SERVICE INFORMATION

Vol. 1 No. 5

LAND-ROVER PETROL AND DIESEL MODELS

July, 1972

Fig. 1 Location of bush for 4-wheel drive selector rod

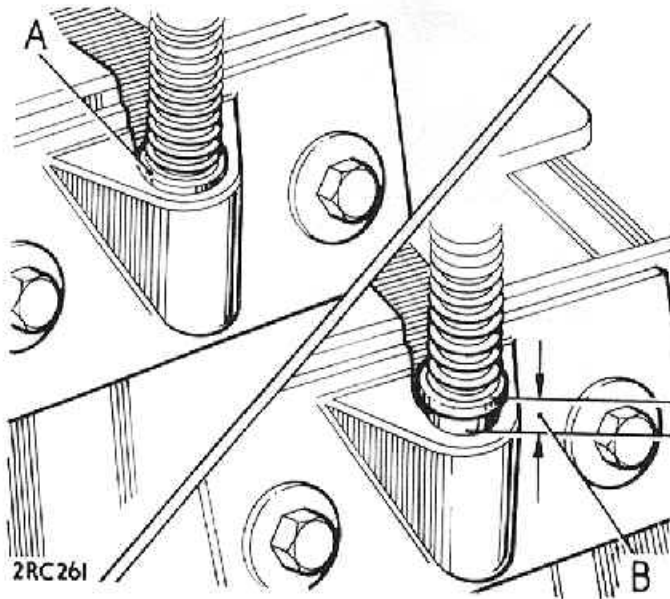
REMARKS: Recent investigations into a complaint of inability to select four wheel drive high range revealed that the selector rod return spring became coil bound. This was caused because the external diameter of the bush was too large, which prevented the bush seating properly in the cover plate.

The bush should fit almost flush with the cover plate, but with incorrect tolerances it may be approximately 50 mm ($\frac{1}{2}$ in.) too high.

A—Bush correctly located in cover plate

B—Bush too high in cover plate which will cause the spring to become coil bound

Should this condition be encountered we recommend that the cover plate be removed and the hole enlarged to accommodate the bush.
